PIC16C76 Rev. A Silicon Errata Sheet

The PIC16C76 (Rev. A) parts you have received conform functionally to the Device Data Sheet (DS30390E), except for the anomalies described below.

Clarifications/Corrections to the Data Sheet:

FIGURE 1: WRITES TO TIMER1 (EXTERNAL CLOCK/OSCILLATOR MODE)

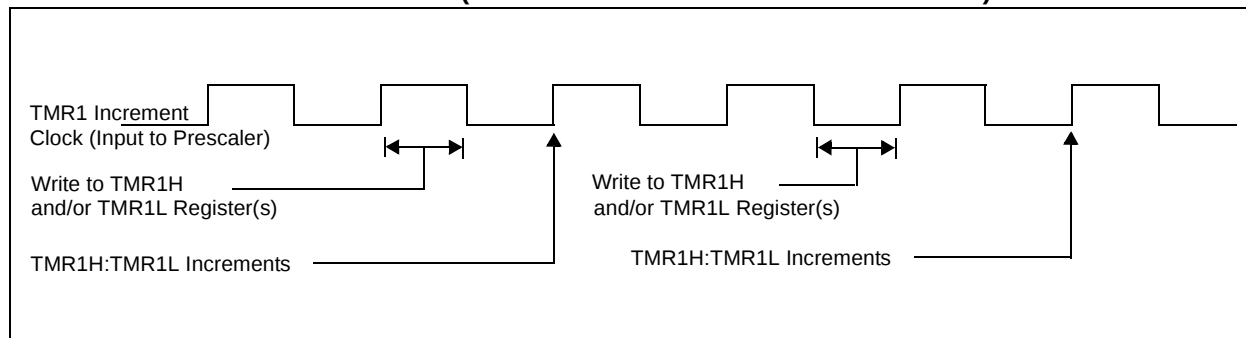
The operation of Timer1 needs some clarification when the timer registers are written when the TMR1ON bit is set.

The internal clock signal that is the input to the TMR1 prescaler affects the incrementing of Timer1 (TMR1H:TMR1L registers and the Timer1 prescaler). When the Timer1 registers are NOT written, the Timer1 will increment on the rising edge of the TMR1 increment clock.

When the TMR1H and/or TMR1L registers are written while this clock is high, TMR1 will increment on the next rising edge of this clock.

When the TMR1H and/or TMR1L registers are written while this clock is low, TMR1 will not increment on the next rising edge of this clock, but must first have a falling clock and the rising clock, for TMR1 to increment.

Figure 1 shows the two cases of writes to the TMR1H and/or TMR1L registers. Due to the V_{IH} and V_{IL} thresholds on the oscillator/clock pins, external Timer1 oscillator components, and external clock frequency, the Timer1 increment clock may not be of a 50% duty cycle.

The TMR1 increment clock is out of phase of the T1OSO/T1CKI pin by a small propagation delay.
